=====
PennDOT BQAD Publications e-Notification
Bureau of Design
Bridge Quality Assurance Division
=====

Interim Revision to Bridge Standard Drawing(s)	BD-612M, Shts. 2 & 3
--	---------------------------------

Interim Revision to Bridge Standard Drawing(s)	BD-632M, "R.C. Box Culvert", sheets 1, 3, 5, 9 and 10, dated 12/29/2008. Deeper Inlet Apron Cutoff Walls, Impervious Wingwall Backfill and Multiple Opposing Apron Baffles.
--	---

Interim Revision to Bridge Standard Drawing(s)	BD-632M, "R.C. Box Culvert", sheets 1, 4, 5, 9 and 10, dated 12/29/2008. Clarification of Backfill Material - Type, Placement Limits and Preformed Drain at Weep Holes.
--	---

RECOMMENDED JULY 9, 2010	RECOMMENDED JULY 9, 2010	SHEET 1 OF 11
CHIEF BRIDGE ENGINEER	DIRECTOR, BUREAU OF DESIGN	BD-632M

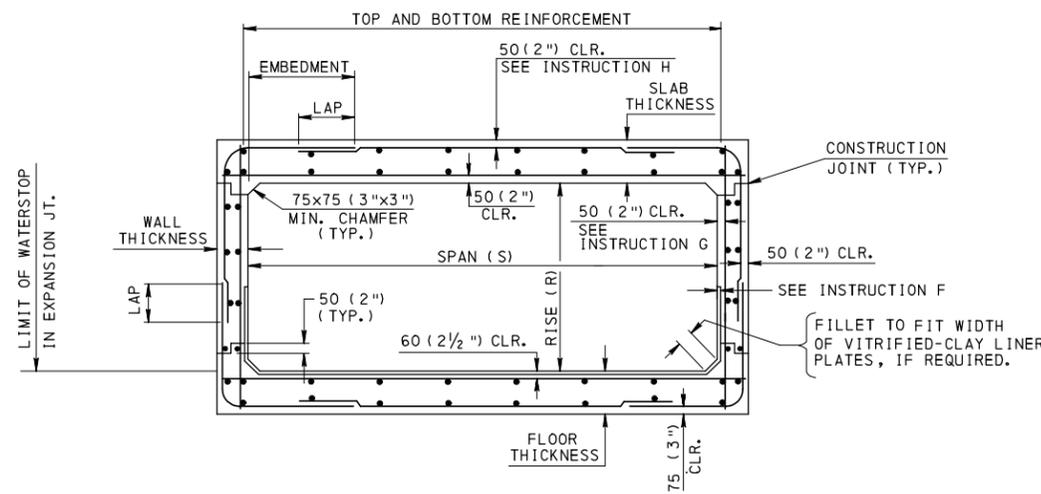
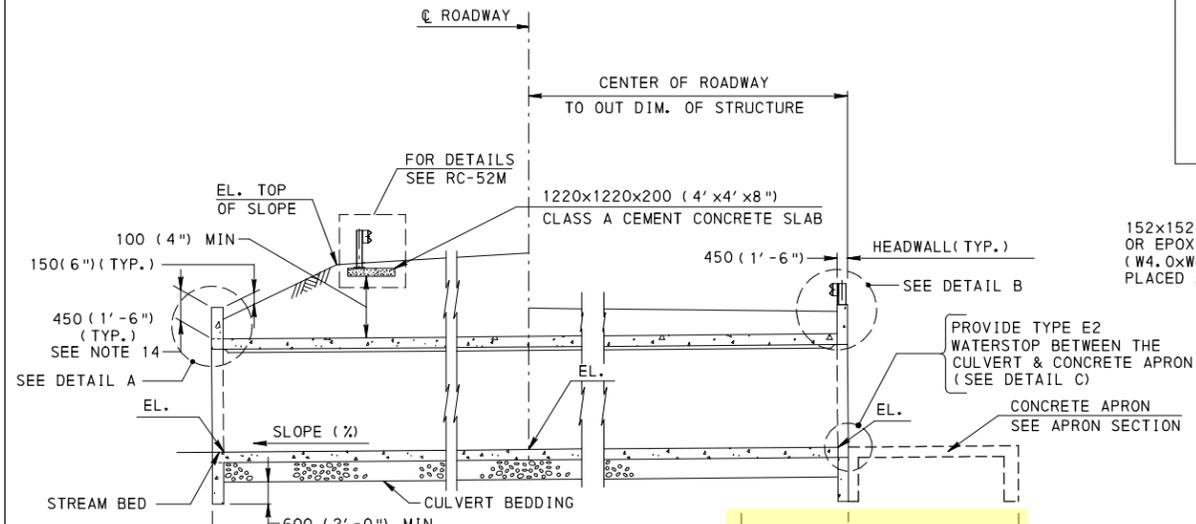
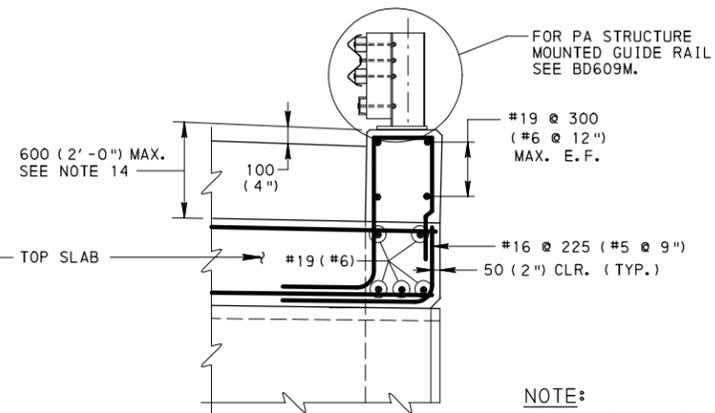
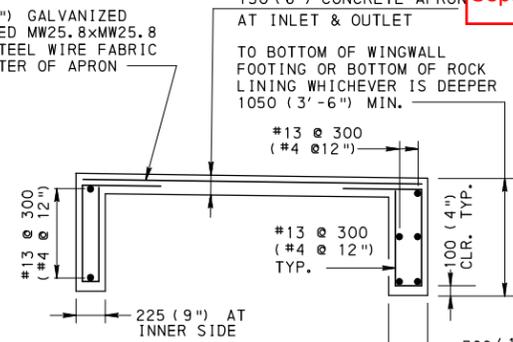
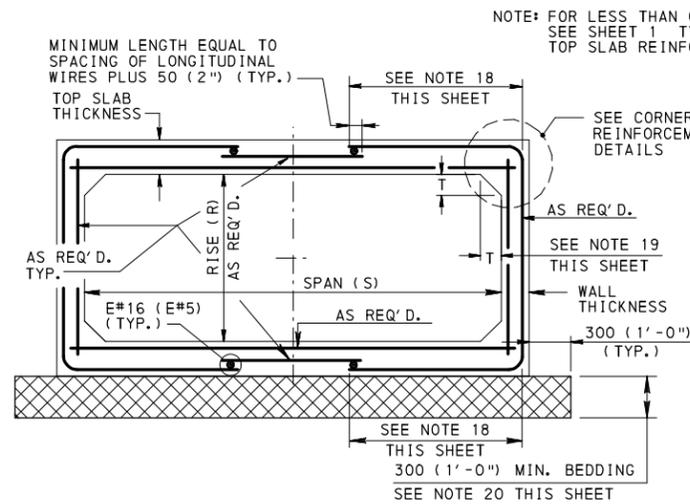
1. Compacted No. 2 Coarse Aggregate or Flowable Backfill must be placed behind inlet end wing walls and for a minimum length of 10'-0" along the sides of the box culvert instead of the entire length as indicated in Section P-P of e-Notification No. 28. This backfill is to be placed a minimum of 2'-0" above the normal stream elevation. The placement limits of this backfill material has been added to the box culvert Elevation on Sheet 1 along with new Note 21.

2. Note 12 is revised to include a statement on use of preformed drain at weep holes that are within this backfill. PREFORMED DRAIN detail added to show proper placement of preformed drain at weep hole locations that are within the compacted No. 2 Coarse Aggregate or Flowable Backfill (See Sheet 5).

3. Rock Lining placement modified to not indicate it extending behind the wing walls on plan views.
4. New Note 28 was added to Sheet 4 to reference Notes 12 and 21 on Sheet 1.

RECOMMENDED JULY 9, 2010	RECOMMENDED JULY 9, 2010	SHEET 5 OF 11
CHIEF BRIDGE ENGINEER	DIRECTOR, BUREAU OF DESIGN	BD-632M

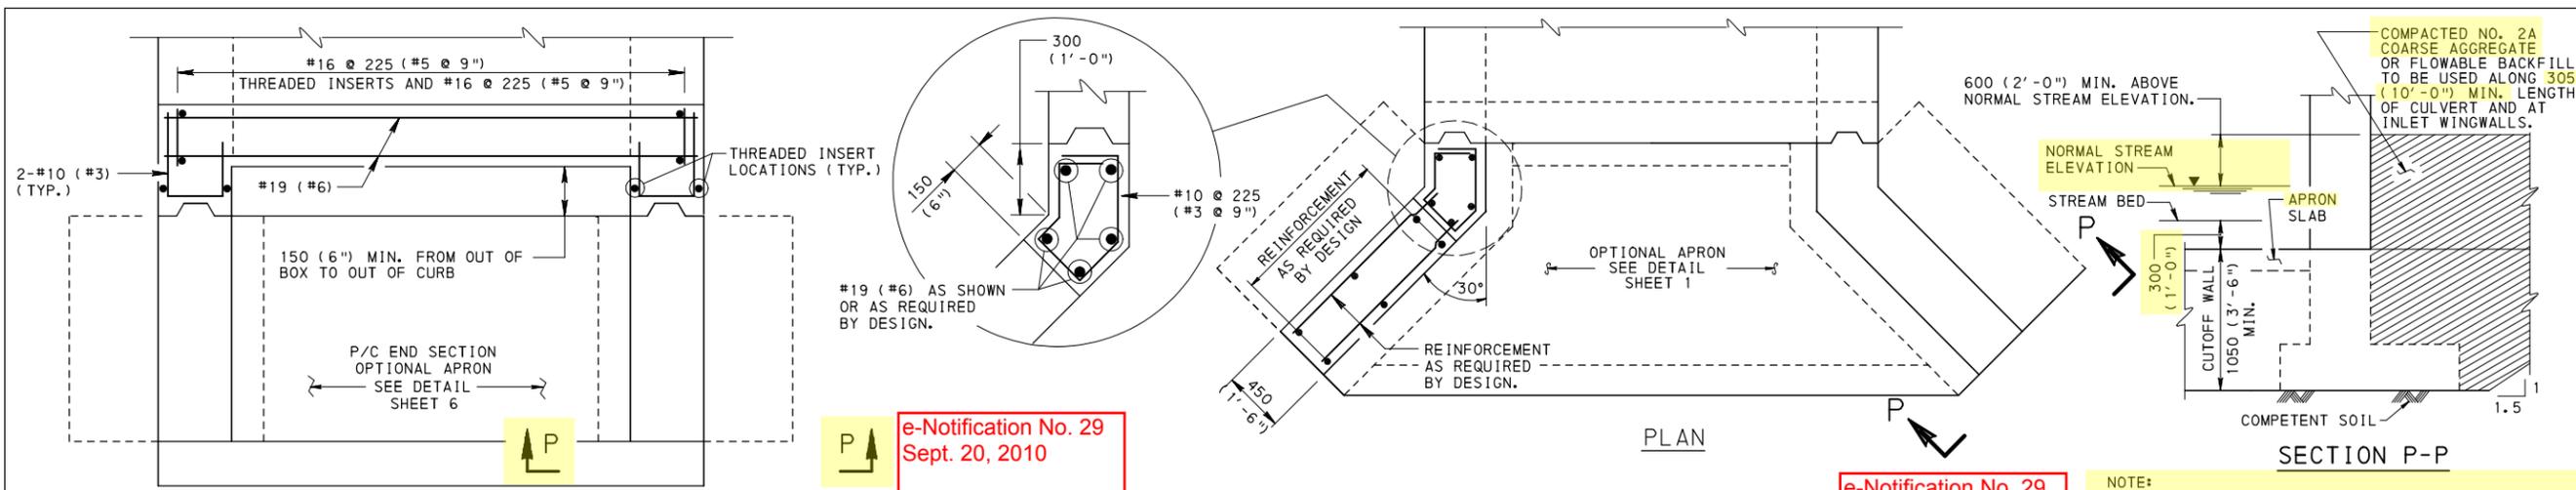
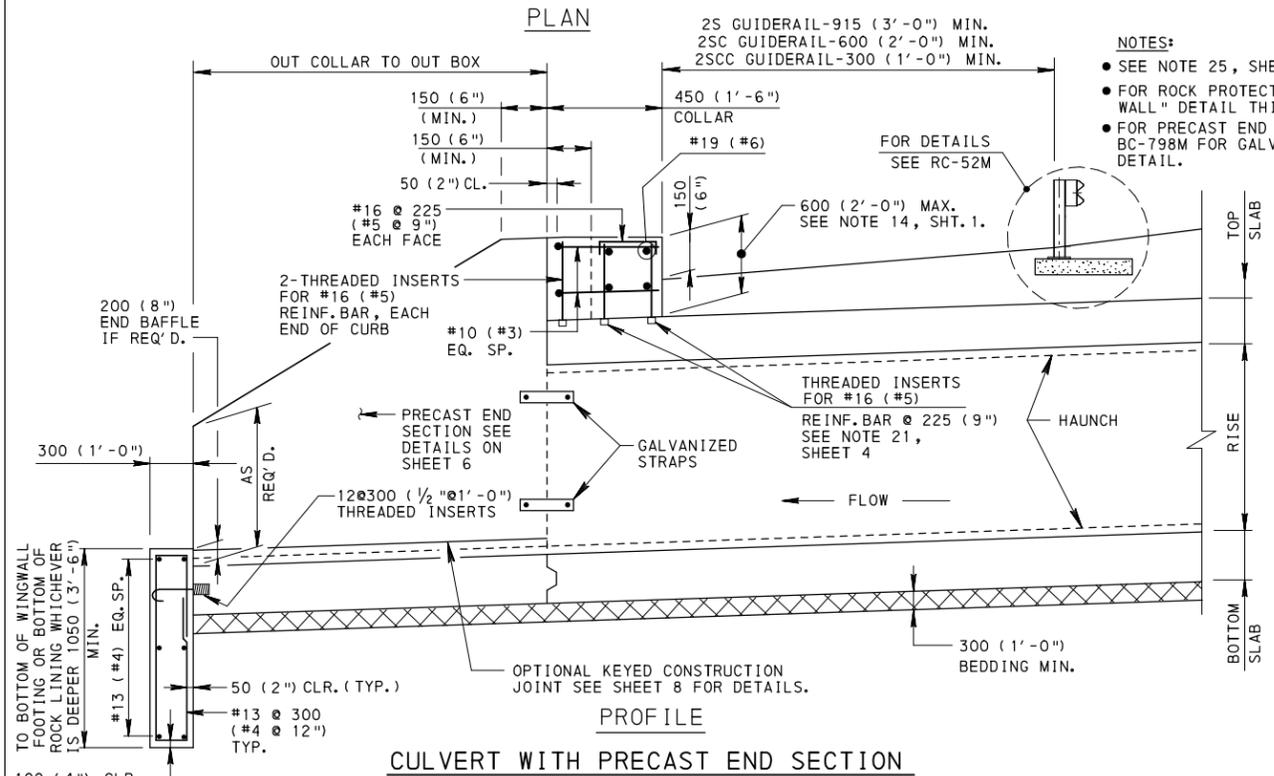
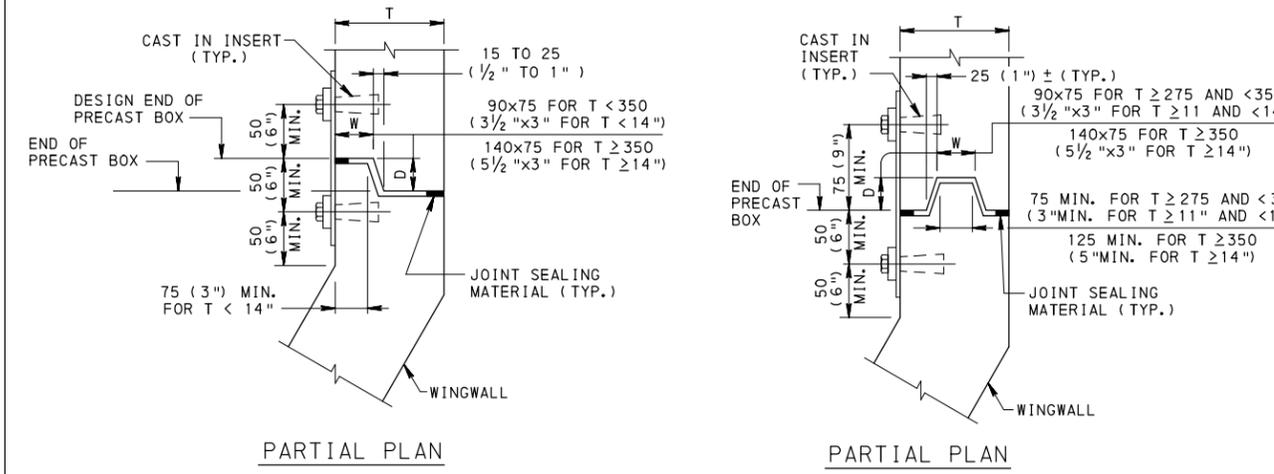
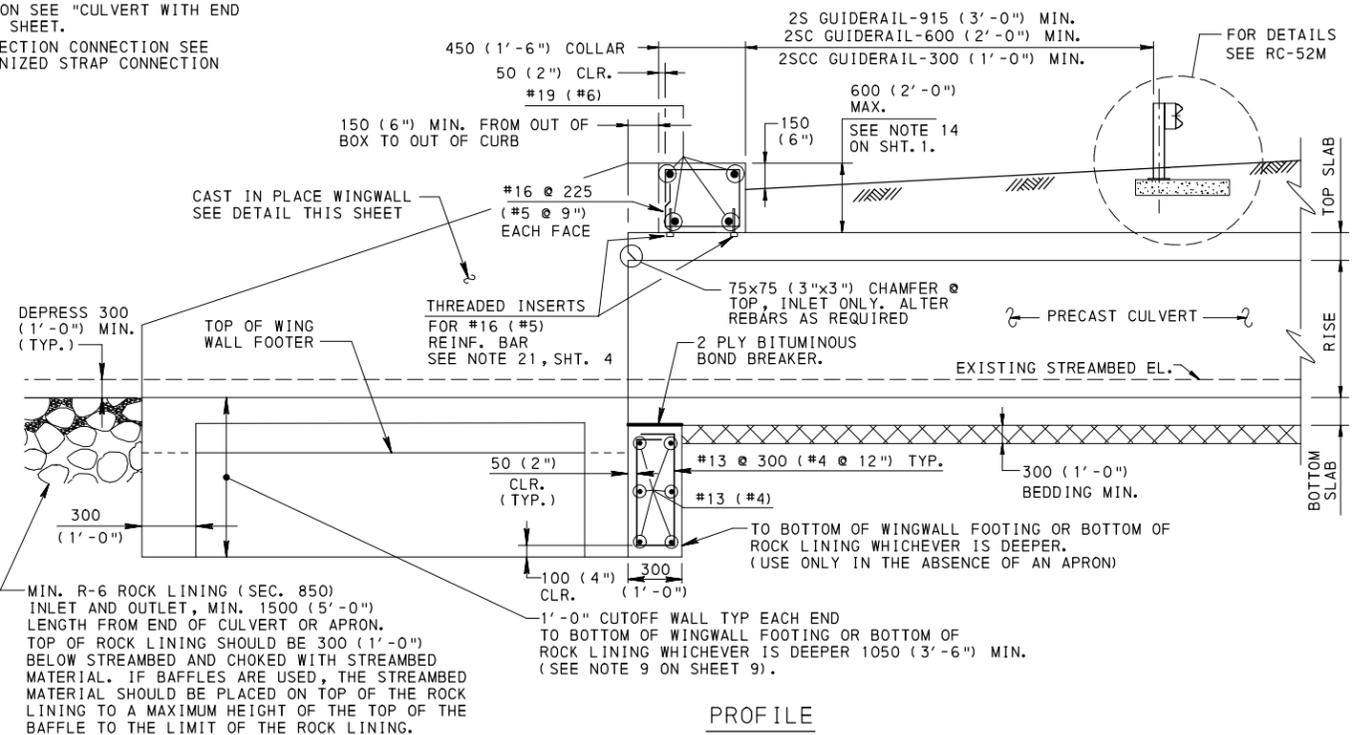
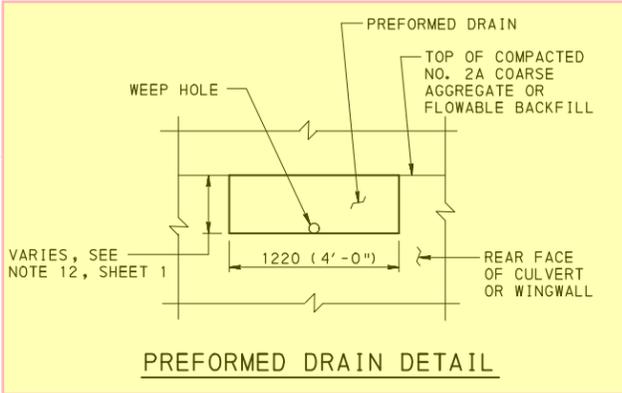
NOTE: DESIGNER TO MODIFY AMOUNT OF COMPACTED NO. 2A COARSE AGGREGATE OR FLOWABLE BACKFILL TO PROVIDE ADEQUATE PROTECTION AGAINST PIPING OF STREAM FLOW THROUGH FILL AT INLET END OF CULVERT.
